Section 75W Modification Application 2 - Bodangora Wind Farm

Bodangora Wind Farm ("**Project**") is a proposed wind farm development located approximately 4 km north-east of Bodangora and 15 kilometres north-east of Wellington, in the recently formed Dubbo Regional Council.

Attachment A - Figures Showing Substation Relocation

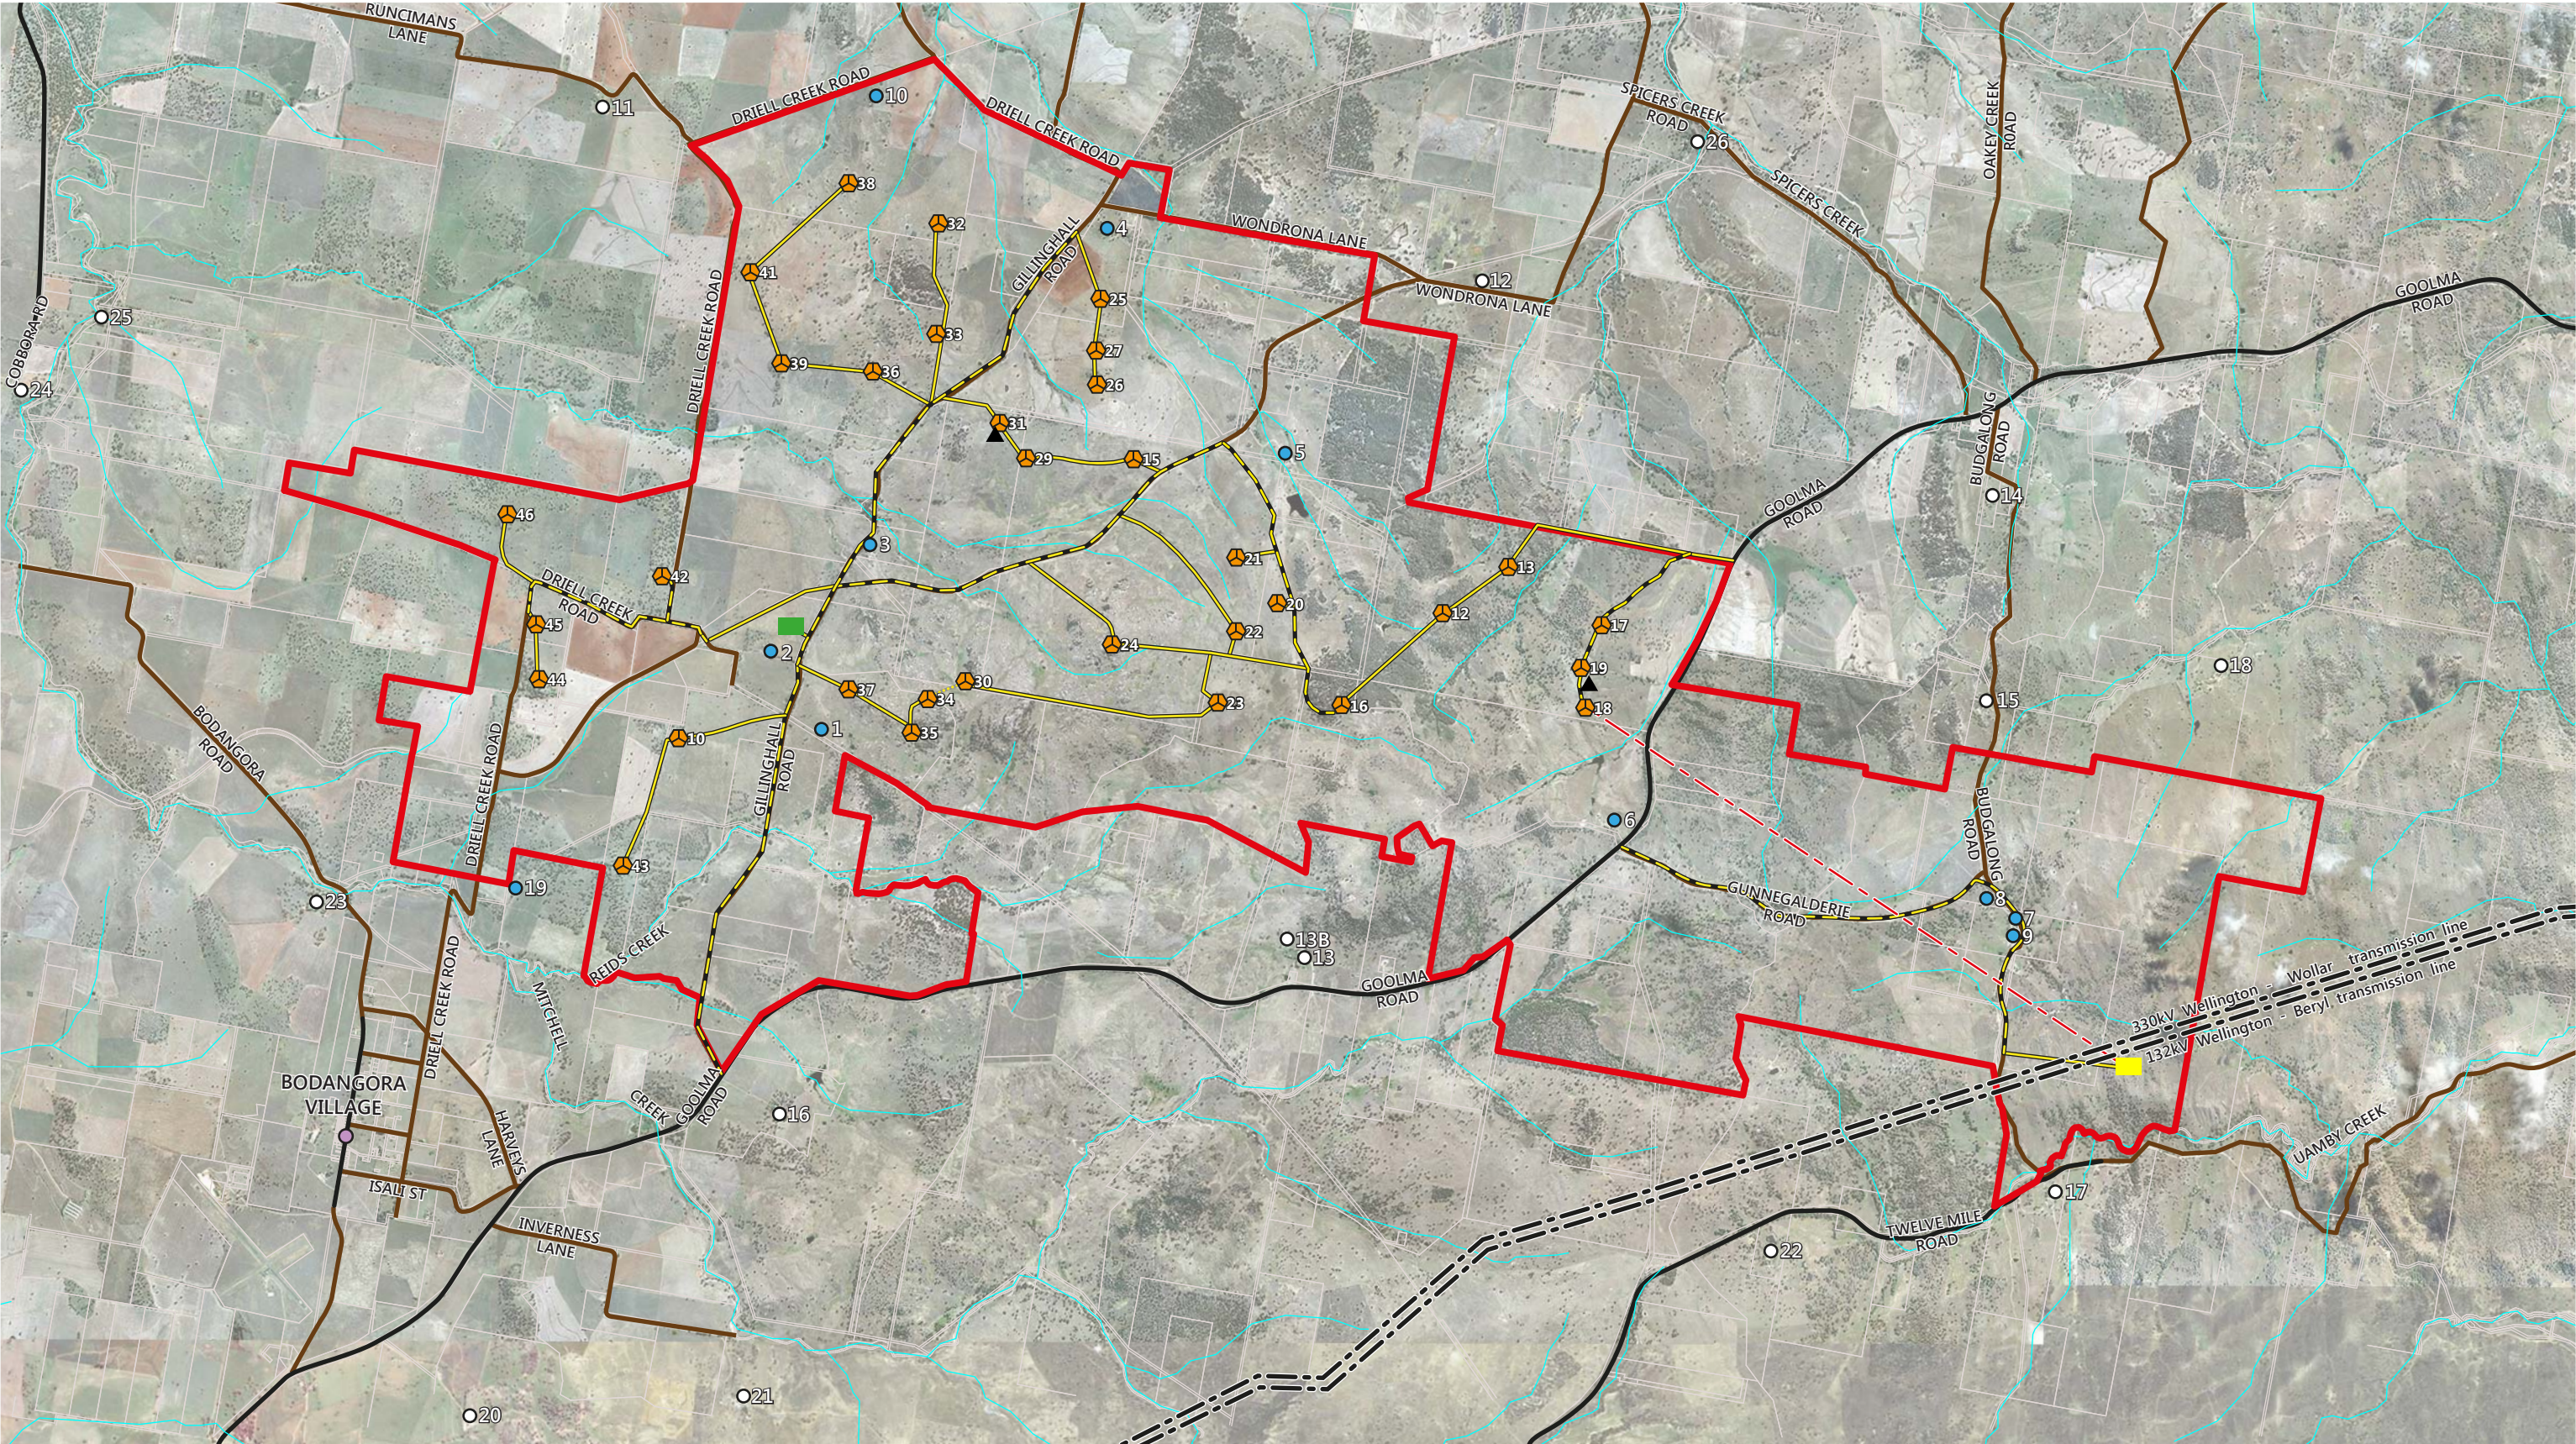
Substation Relocation

Transgrid has approved a 'T' style connection concept which will enable the Project to connect near to pole 88 on the existing Wellington to Beryl 132kV line (94b) at a location adjacent to Gunnegalderie Road. This means that it has become necessary to update the location of the substation to the central part of the project area. In addition, the Proponent seeks approval for any subdivision required to enable land access over the substation site to be delivered to Transgrid (including either by the subdivision of the land into a new lot or a deemed subdivision arising from the grant of a long term lease for the substation).

- I. the current location of the substation;
- II. the proposed revised location of the substation;
- III. the indicative footprint of the substation at the revised location; and

Attachment B – Figure showing revised cable layout

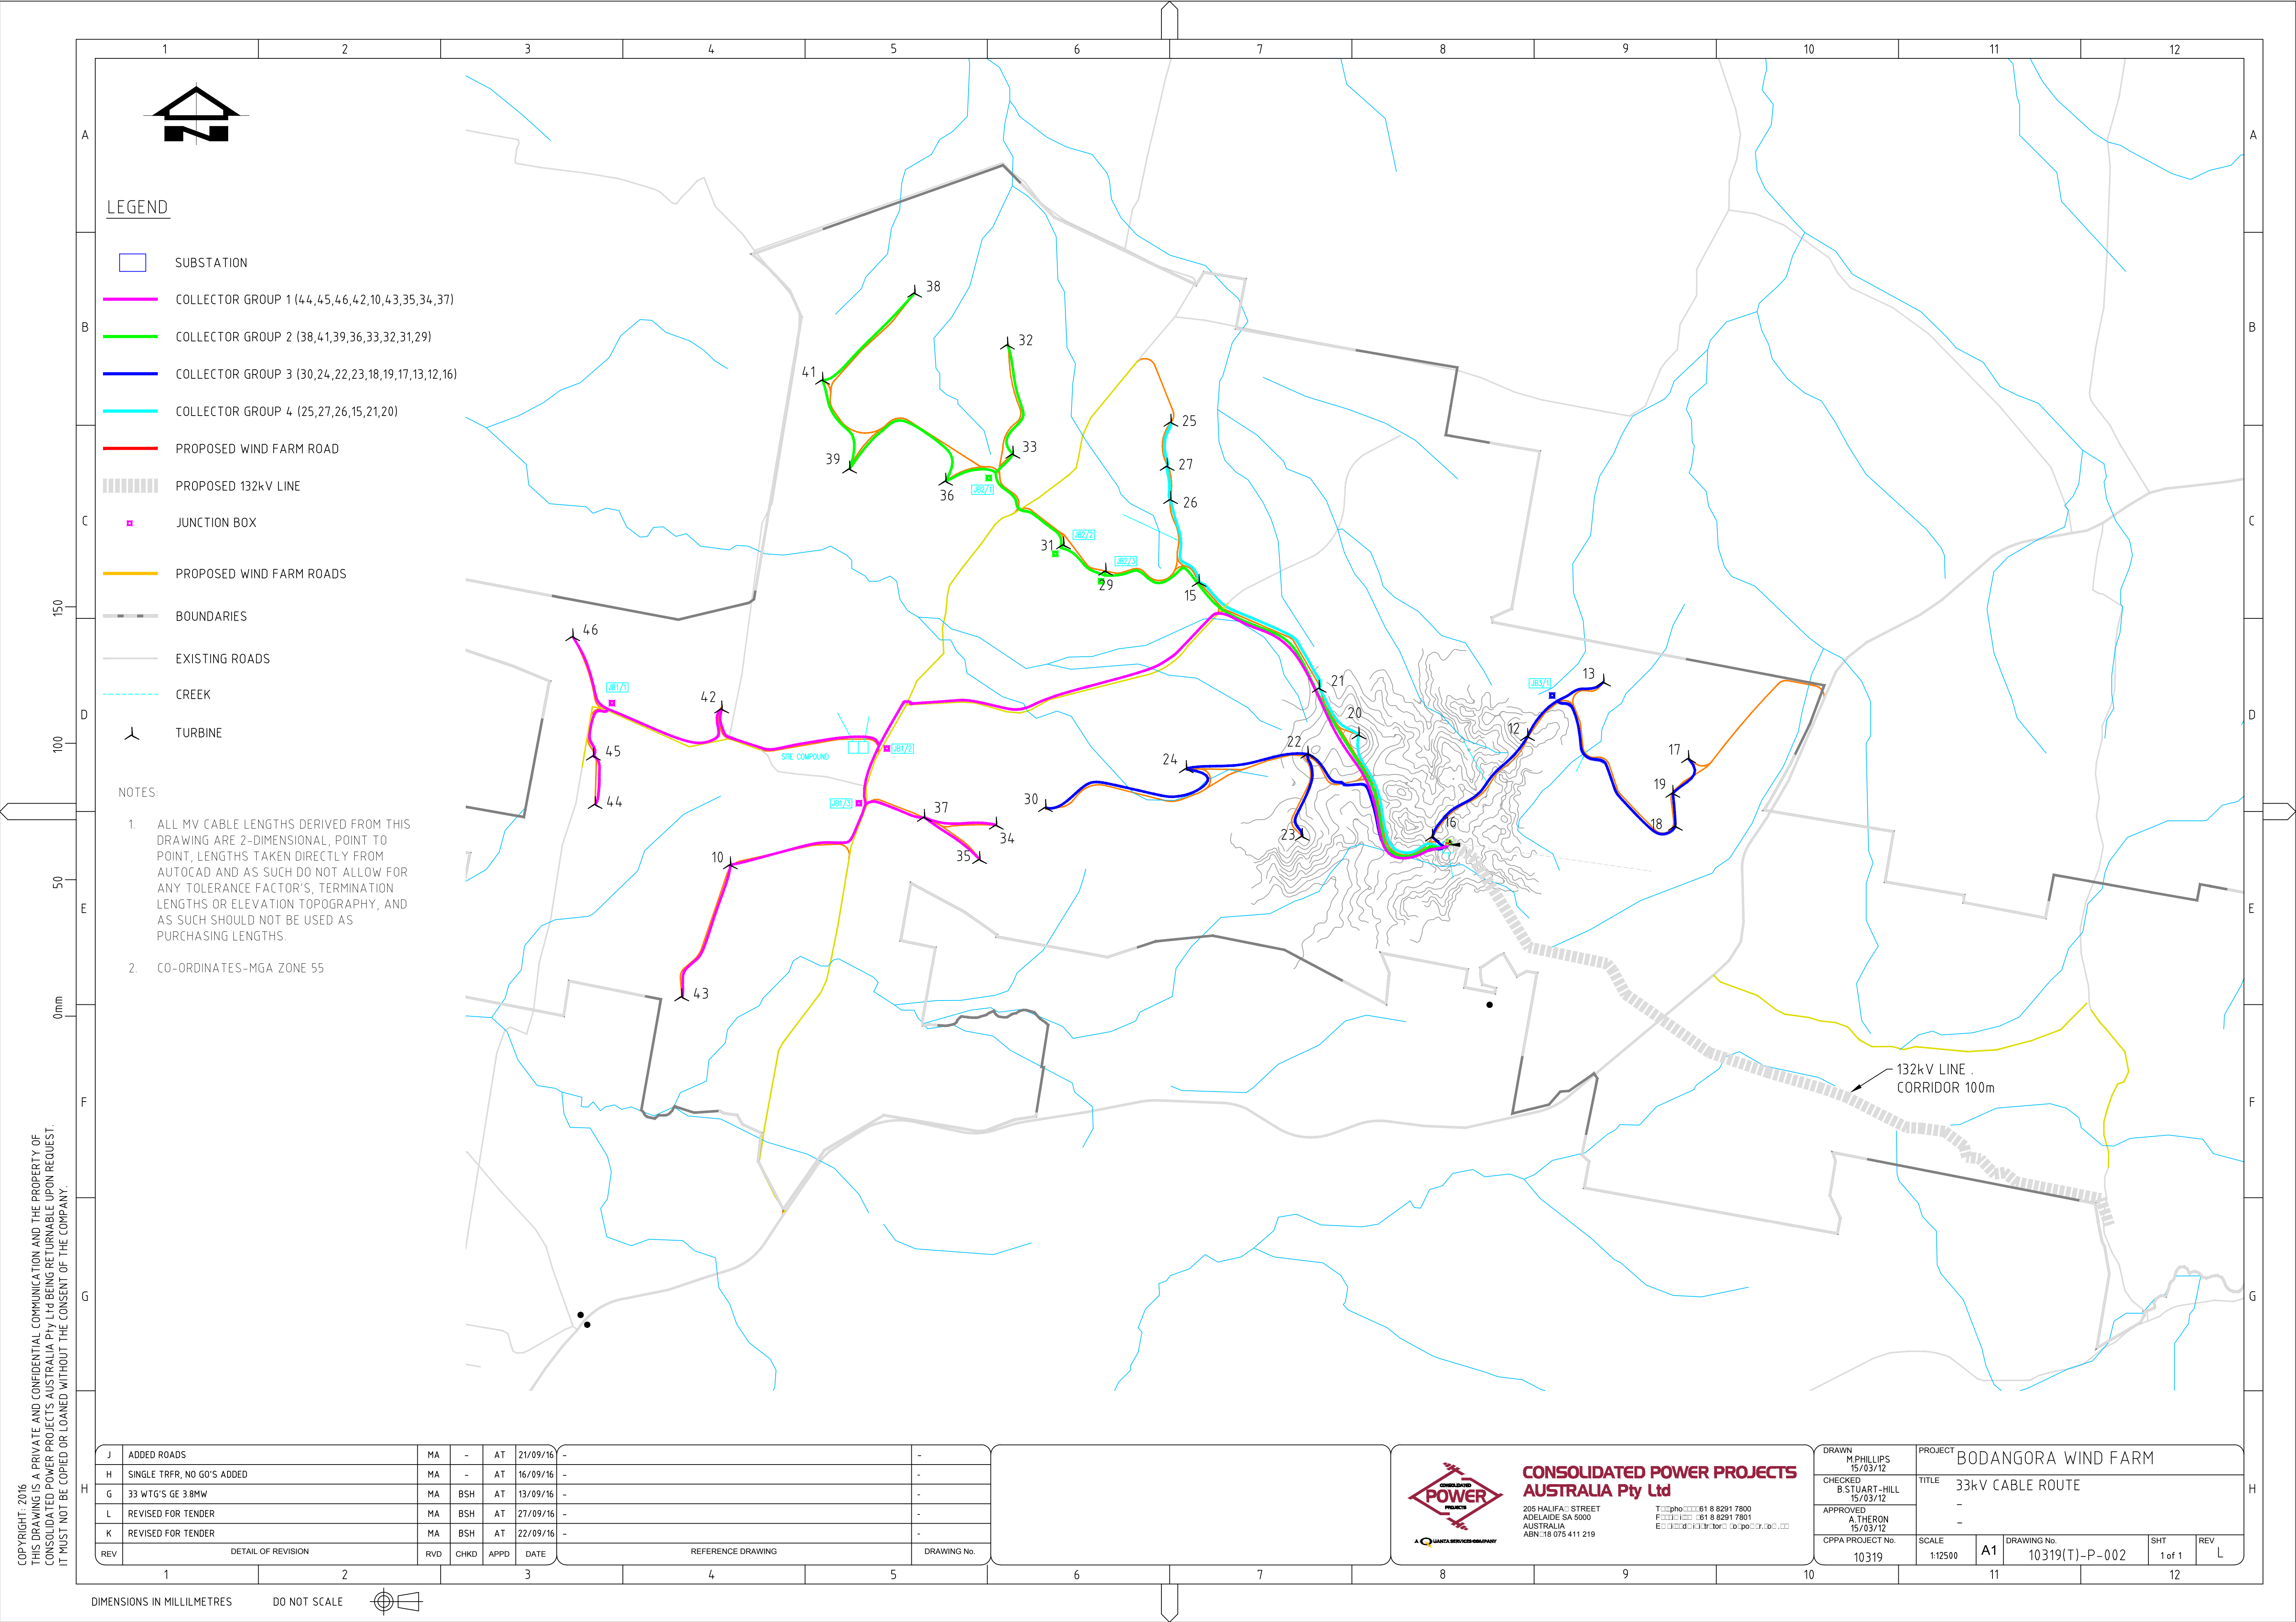
The modification application seeks approval to locate and access the proposed connection feeder line anywhere within the 100m corridor shown in **Attachment B**. This will allow flexibility to further microsite the connection feeder line so as to further minimise impacts, including on

Figures showing the proposed corridor for the re-aligned connection feeder are included in **Attachment B** and **Aii**.

- Removal of the cable between wind turbine 30 and 34;
- Consolidation and realignment of cable between wind turbine 23, 24 and 30;
- Realignment of cable between wind turbine 17 and 13;
- Realignment of cable between wind turbine 26 and 15; and
- Realignment of cable between wind turbine 23 and 16.
